1 **DEVELOPMENT OF 19 DWELLINGS, 360 PRINCES HIGHWAY OFFICER**

FILE REFERENCE INT1745486

It is recommended that the without prejudice plans submitted to Council with respect to planning permit application T160600 and VCAT reference P1056/2017 be supported subject to conditions and a consent order provided to VCAT allowing Planning Permit T160600 be issued authorising the development of a nineteen (19) dwellings at 360 Princes Highway (proposed lot A PS738353A).

On 28 June 2017, Council received without prejudice plans for Council's consideration prior to the scheduled VCAT Compulsory Conference on 24 July 2017. The plans were prepared in response to Councils' grounds of refusal and propose key design changes and removal of two dwellings.

SHEET: TP04 **JOB No:** OFFL/PION/000A
TOWN PLANNING

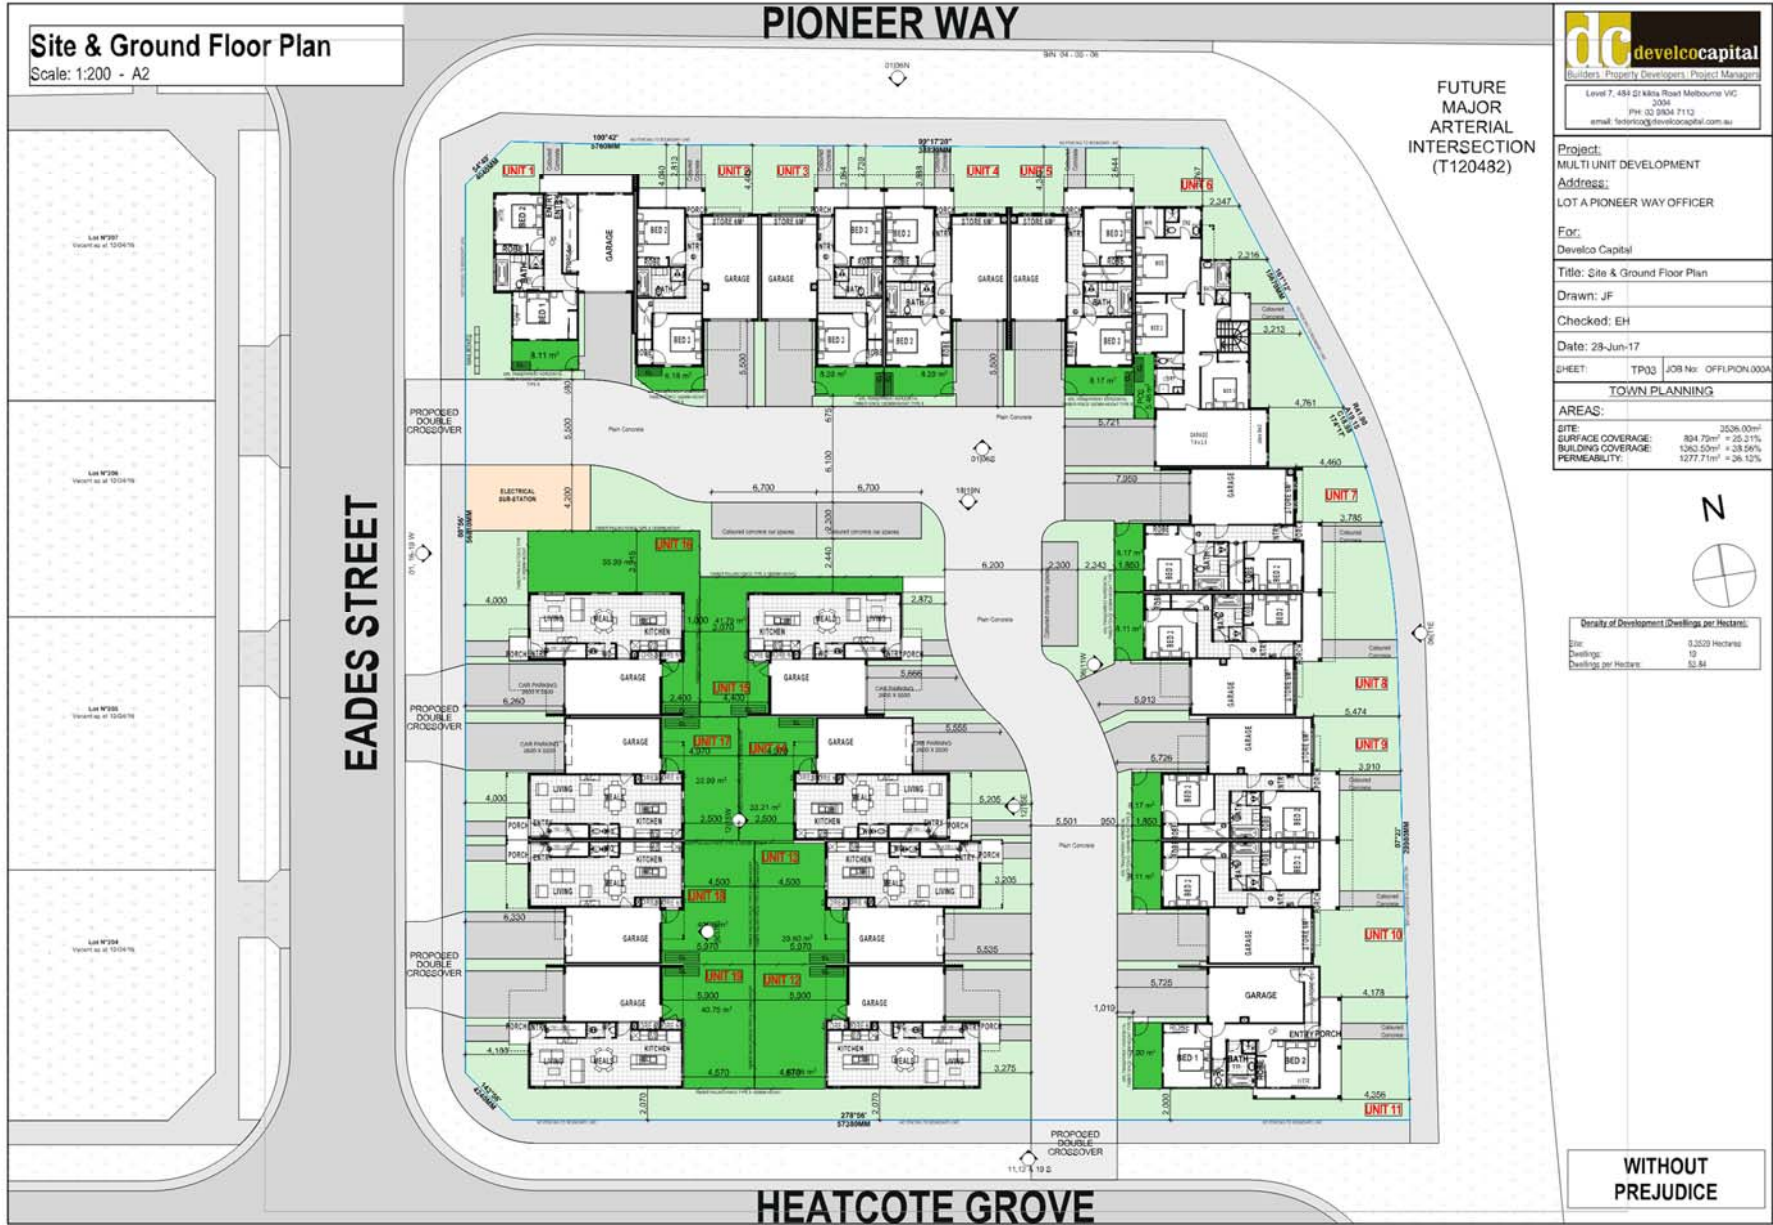
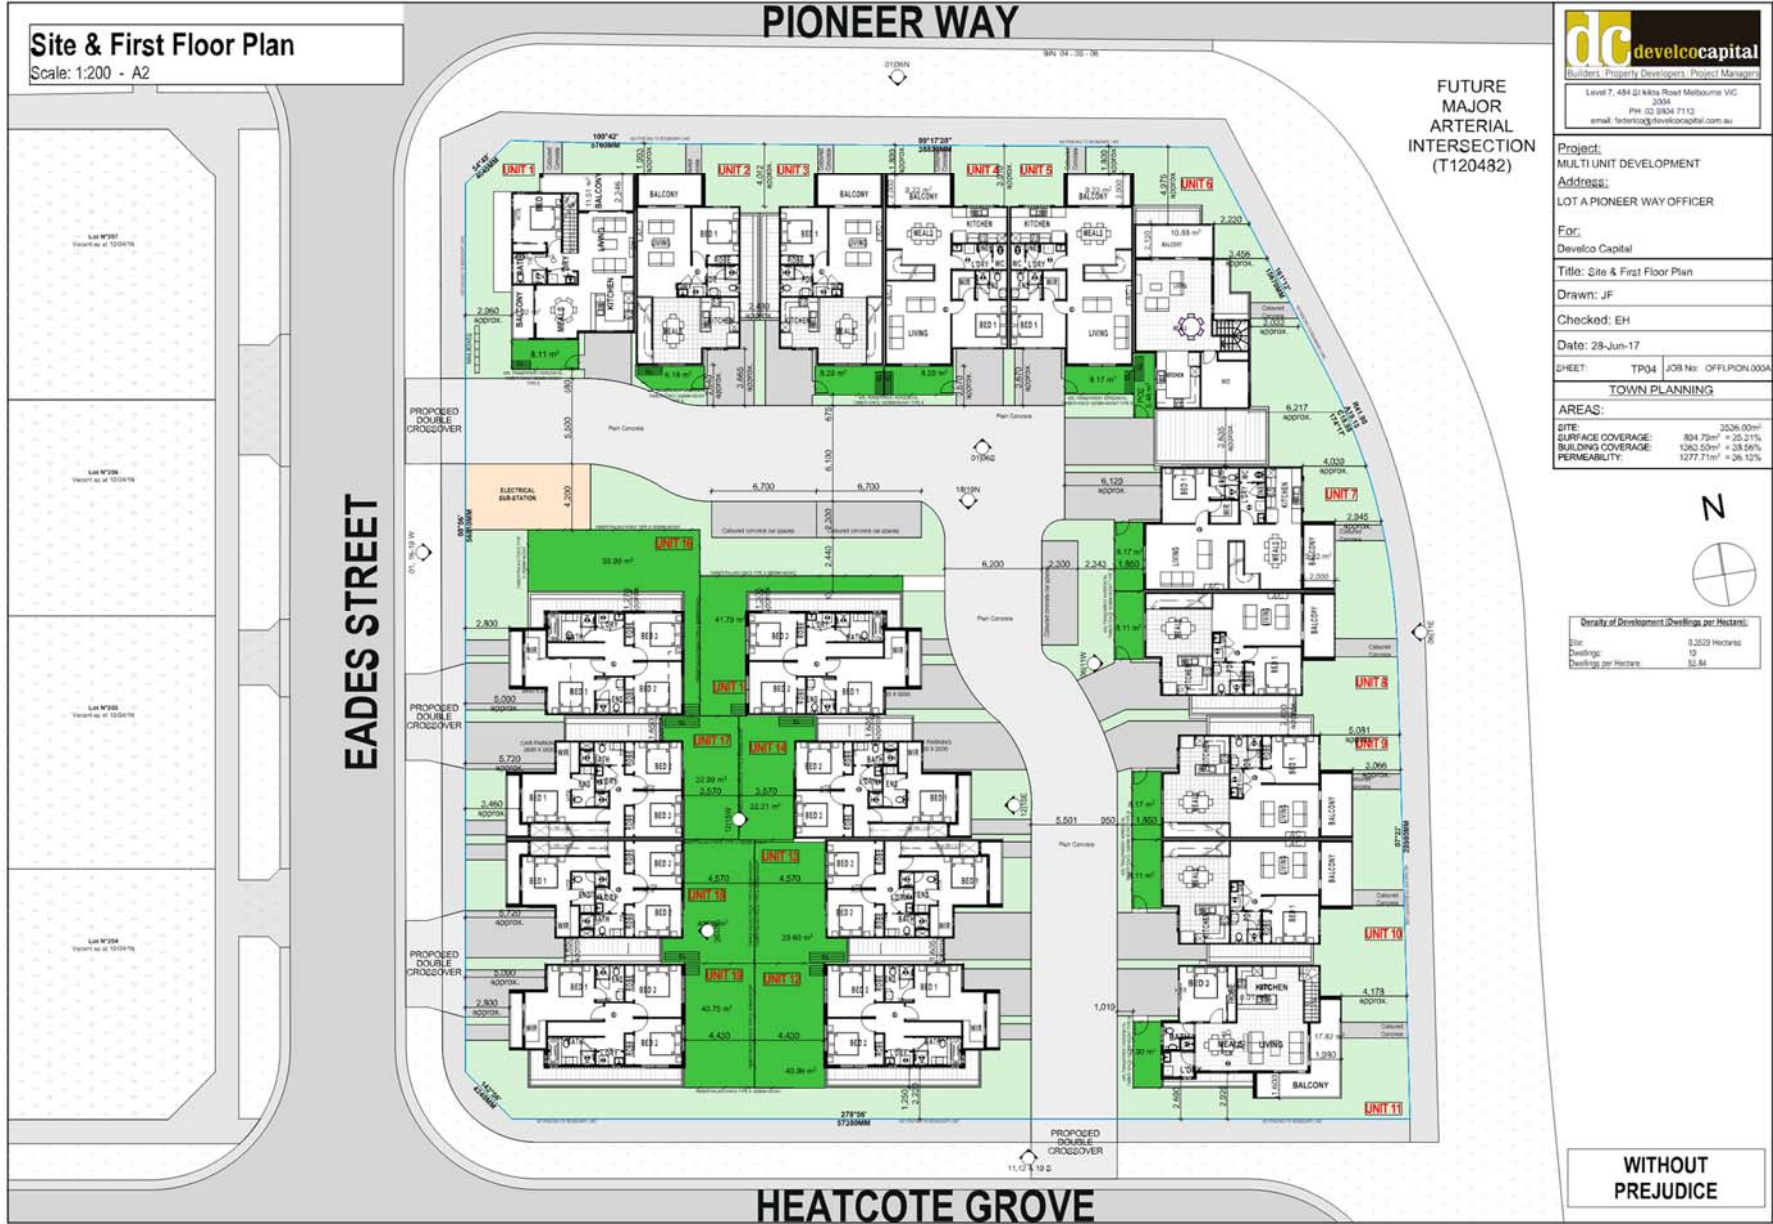
1. The revised plans are consistent with Clause 15.01-1 (Urban Design) and Clause 21.06-1 (Design and Built Form). The proposed amendments will provide improved landscaping opportunities across the site; passive surveillance to the street and internal driveway and a well-articulated quality development.

3. The revised plans provide for a high level of compliance with Clause 55. Specifically:
 - a) The increase in front setback and upper storey separation reduce the visual bulk presenting to the streetscape and increase landscaping opportunities within the front setback. The height, scale and setback is in keeping with a comparable development approved to the north of the subject site (T150733).

- b) The floor layout of Unit 1 has been rearranged so that it presents an active corner frontage to corner frontage to Eades Street/Pioneer Way. Further, the garage has been relocated internal into the site which brings the living rooms to the west side and increases passive surveillance of Eades Street.

- c) The setbacks provide an acceptable streetscape outcome with setbacks of generally 4 metres to grounds level to all street frontages. Heathcote Grove is provided with a 2 metre setback at ground level which is compliant with Clause 55 Standard B6 requirements.

- d) The deletion of two dwellings provides an improved solar access into the courtyards of Units 12 to 19 (inclusive) and meets the objectives of Clause 55.03-5 (Energy Efficiency).

- e) The development provides for relatively low fencing abutting the internal driveway which is 40% transparent. In addition, the floor layout has been amended by including habitable windows facing the internal driveway which will increase increasing passive surveillance opportunities.

- f) The visitor spaces have been amended to comply with Clause 52.06 and rearranged to allow for convenient access.
 - g) The proposal is considered to satisfies Clause 55.04-8 relating to noise. Any noise above permissible limits generated by the future arterial road will need to be dealt with by the Roads Authority.

- h) All units have been amended to comply with Standard B28 of Clause 55.05-4 (Private open space).
 - i) All units have been amended to comply with Standard B30 of Clause 55.06-1 (Storage).

- j) The proposed building expression and materials/finishes have been rationalised and additional windows/punctuation to the elevations incorporated to provide a well articulated building. The rear wall of garages abutting the street will be disguised as room windows to avoid appearing as rear garage to the streetscape. The changes provide a satisfactory response to Standard B31 of Clause 55.06-2 (Design Detail).

- d. Balcony of dwellings 2, 3, 9 & 10 to indicate a minimum width of 1.6 metres and area of 8 square metres consistent with Clause 55.05-4 of the Cardinia Planning Scheme

- e. Each three bedroom dwelling to include a notation of a tandem parking space with dimensions and clearances consistent with the design standards of Clause 52.06-9.

- g. Dwelling 12 and 19 to provide a porch/pedestrian access to Heathcote Grove to provide a sense of address and appropriate interface to Heathcote Grove.

- h. All rear wall garage windows which face the street to be appropriately tinted to avoid presenting as a garage to the streetscape.
2. The development as shown on the endorsed plans must not be altered or modified except with the written consent of the Responsible Authority.
